Nuclear Management Company, LLC
Prairie Island Nuclear Generating Plant
1717 Wakonade Dr. East
Welch MN 55089

#### PRAIRIE ISLAND NUCLEAR GENERATING PLANT

Docket Nos. 50-282 License Nos. DPR-42 50-306 DPR-60

#### License Amendment Request dated December 11, 2000 Conversion to Improved Technical Specifications

## TABLE TS.1.1-1 (Page 1 of 1)

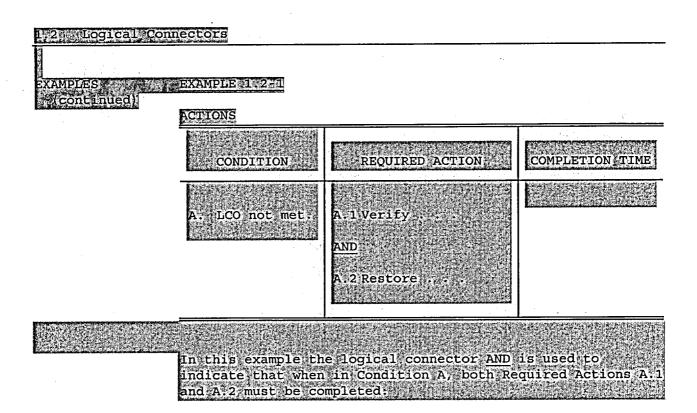
L1.0-22
